Enclosure 2
Meeting Summary Handouts
of the January 19, 2012
ROP Public Meeting

Reactor Oversight Process Task Force FAQ Log

**Tentative NRC Response to
FAQ 11-12, FitzPatrick Downpowers**

Plant: James A. FitzPatrick Nuclear Power Plant
Date of Event: June 7, 2011 & June 9, 2011
Submittal Date: Introduced October 26, 2011
Licensee Contact: Gene Dorman 315-349-6810 / gdorman@entergy.com
NRC Contact: Ed Knutson 315-349-6667 / edward.knutson@nrc.gov
Performance Indicator: Unplanned Power Changes per 7,000 Critical Hours
Site-Specific FAQ (Appendix D): YES / NO
FAQ requested to become effective when approved or _____.

Diagram 1: Low flow area with debris build-up behind Boot

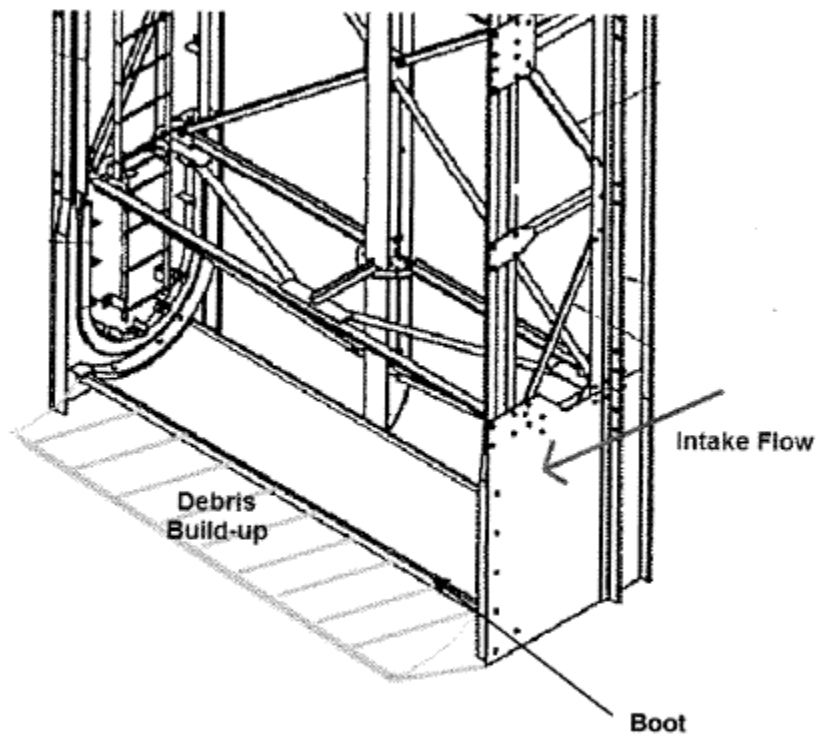
Based on the need to downpower the unit JAF performed an apparent cause evaluation and determined that the fouling observed was from a previously unidentified source. Based on the design of the boot and the cement, it appears that a low flow area may be forming just past the

boot. There is a possibility for small debris such as silt, sand, and broken zebra mussel shells to settle in this area south of the screens (pump suction side). In this area, the silt may settle out past the boots and build up to a level to meet up with the process flow. This condition would only take a short period of time to build-up and then would remain in the condition until cleaning could remove the debris.

During normal operation, this debris build-up is not a significant threat to fouling because the debris is settled. However, this area becomes vulnerable when the gates are installed because of the change in flow patterns and increased velocity.

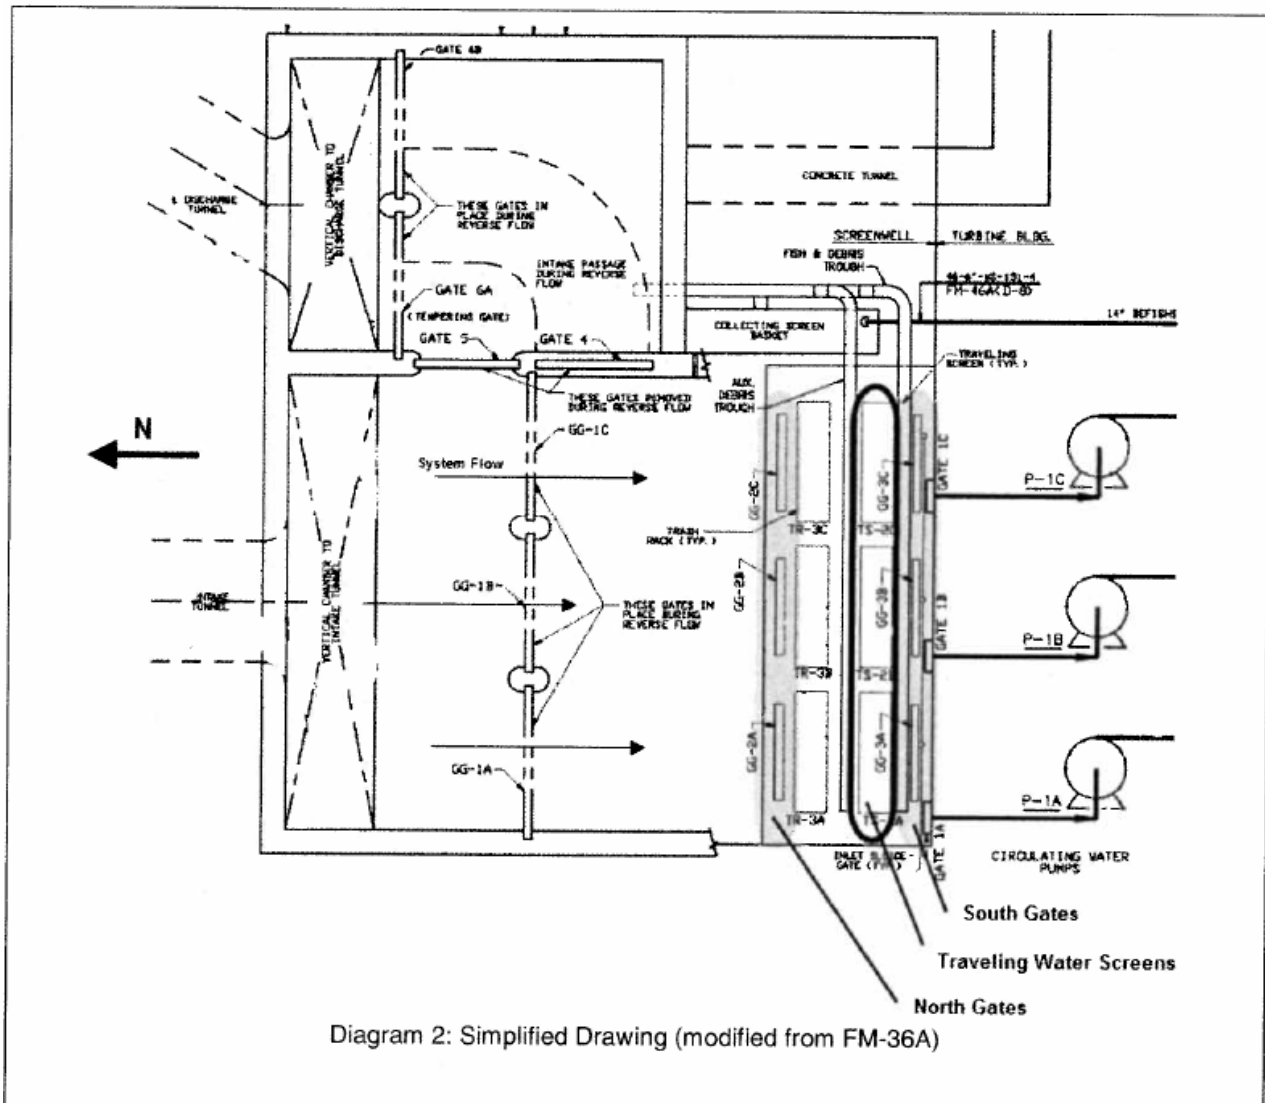
As noted above to minimize the impact of the marine debris buildup in the forebay, the annual cleaning and inspection of the intake canals was performed the week prior to the annual PM to inspect the travelling water screen boot. The cleaning included the areas of the forebay from the tempering gate to the trash racks and the area between the trash racks and the screens. However, due to the configuration of the traveling screens, pump bays, and isolation gates (see Diagram 2 below), the area south of the screens was not cleaned because it is not accessible during operation.
